TOWN OF WILLISTON
DEVELOPMENT REVIEW BOARD
November 9, 2021, 7:00 PM
Town Hall Meeting Room | 7900 Williston Road

WILLISTON DEVELOPMENT REVIEW BOARD STAFF REPORT

DP 09-01.23 The Snyder FC Commercial Properties LLC and Rieley Properties LLC requests a discretionary permit to construct building H (restaurant) and the urban park at Holland Lane and Market Street in Finney Crossing in the Taft Corners Zoning District (TCZD).

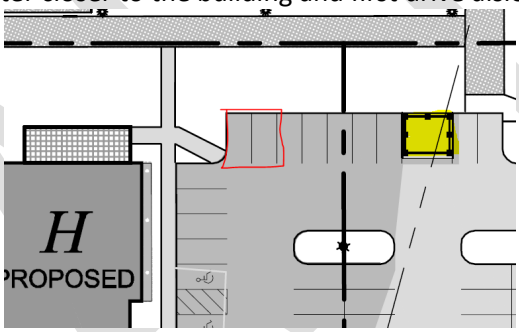
John H confirmed dumpster enclosure is well located. He is concerned that the back of the enclosure is adjacent to hotel walkway and asked what kind of screening is provided for members of public walking along that pedestrian path. Chris S advised that design of the enclosure is a fence which is appropriate, and they can add some landscaping along Curtis Lane bike path. John H thinks it needs attention as he is concerned with the pedestrian environment.

16.7 Solid Waste: The DRB must decide if the enclosure location and screening complies as proposed. WDB 16.7 prefers screening solid waste containers by placing them in the structure they serve or walls that are an architectural extension, but the DRB may permit an enclosure away from buildings. Given the site lay out (and Fire Dept's preference is trash containers 30-ft from buildings) it is not feasible to locate the enclosure within or attached to the building. The applicant proposes a cedar enclosure, like the one provided at Building J. The placement in the parking lot is designed for hauler access using the drive aisle, but it may be possible to locate the dumpster closer to the building and first drive aisle (red box):

a. Final plans must include additional landscape screening between the dumpster enclosure and Curtis Lane bike path per WDB 18 & 23.

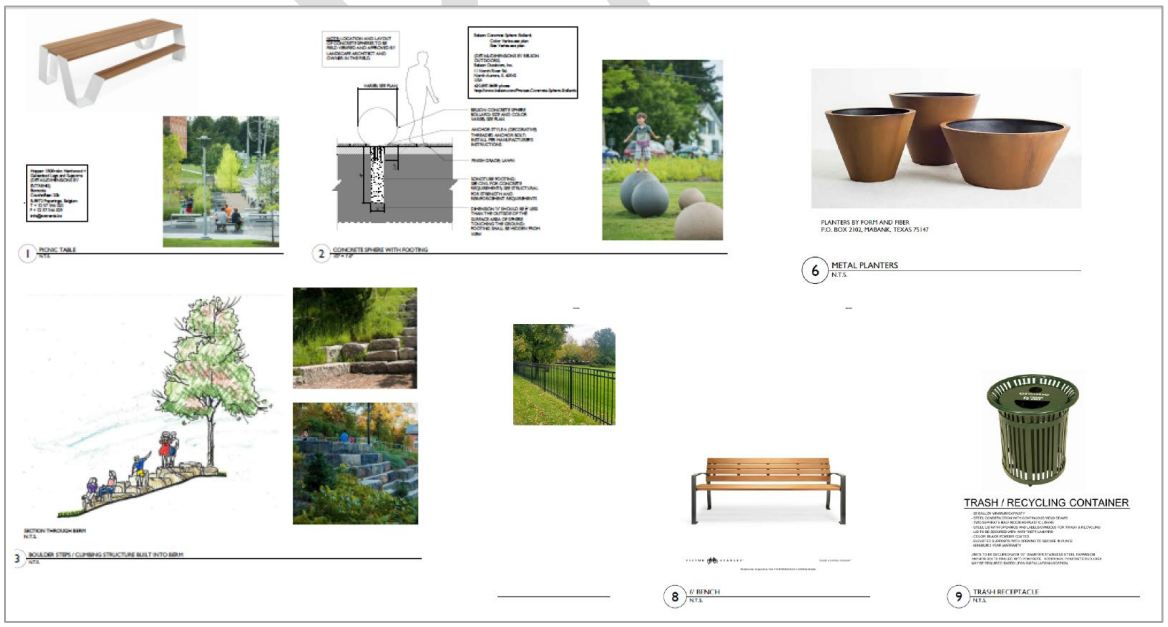
The applicant's original submission did not respond to all pre-app recommendations: particularly "comfortable places to sit (benches with backs, tables, dry lawns, etc.), areas for children to play, and vignettes of landscaping and park elements to draw people into the space" and "screening rooftop mechanical with parapet." The applicant submitted revised landscape plans, elevations, and narrative addressing these recommendations.

After the HAAC review, Brian Forrest submitted a comment letter about using hedges to enclose the park space. The landscaping proposed around the park benches are perennials and ornamental grasses.

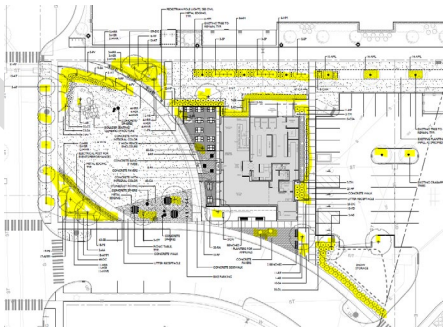
Complies as proposed. Per WDB 41.3.1.3, road setbacks in the TCZD must be landscaped as a Type III or IV buffer. A buffer analysis table is not provided because Lot C-10 is internal to Finney Crossing and the landscape buffers of WDB 23 typically apply to exterior property boundaries. Street trees are existing and proposed along Holland Lane and the Market Street driveway. Landscaping and trees are also existing and proposed along the pedestrian path (Curtis Lane extension) between hotel and park/Building H. At pre-application, the HAAC/DRB recommendation additional landscaping.
